No. 91-9

▲ Revised 4-14-93

A. OIL LEAKING FROM WATER PICKUP HOLES IN GEAR HOUSING ON ALPHA ONE GENERATION II DRIVE

MCM 3.0L/3.0LX/4.3L/4.3LX/5.0L/5.0LX/5.7L Alpha/350 Magnum

70501

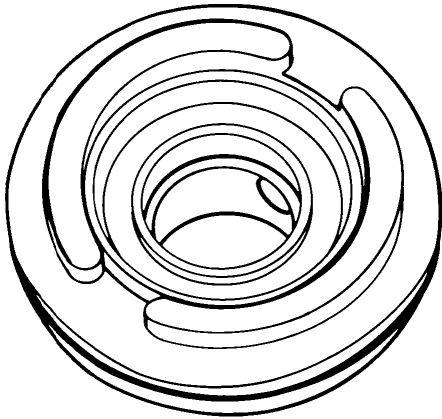
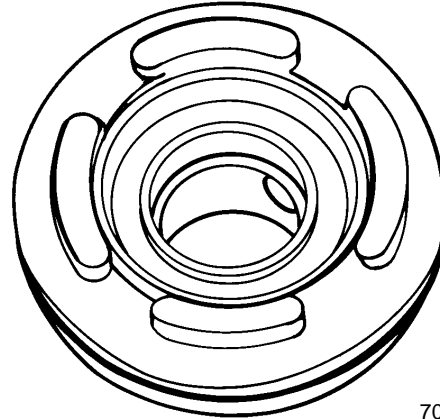
The oil seal carrier is being changed from the brown color (aluminum) material back to a black glass filled nylon material. This new seal carrier will supercede the aluminum version. The new seal carrier can be identified by looking at the base where the old plastic carrier had only two support feet the new one will have four support feet.

A. Old Style

B. New Style

1 seal carrier ▲821759A2

70489

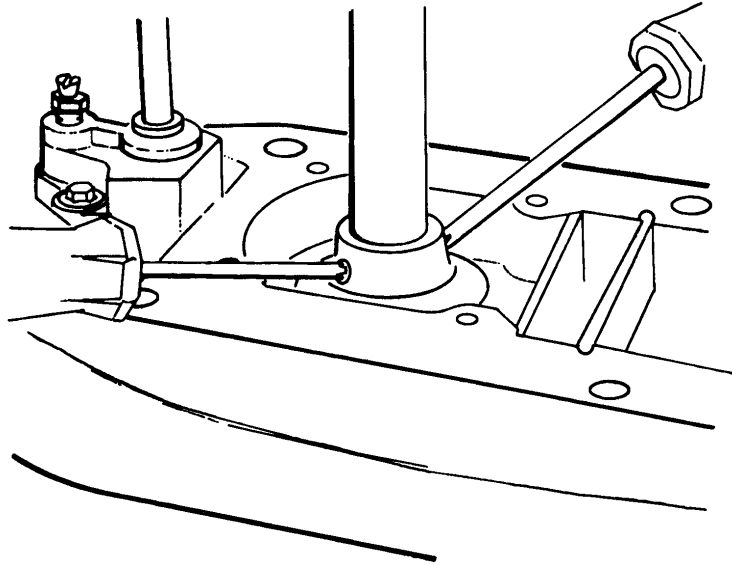
If oil is detected leaking from the water pickup holes in the gear housing, the oil seal carrier under the water pump face plate may be cracked. This would cause oil to leak from the water pickup holes in the gear housing and could lead to gear failure.

Remove cracked carrier from gear housing using a couple of screw drivers to lift it up and out of the housing bore.
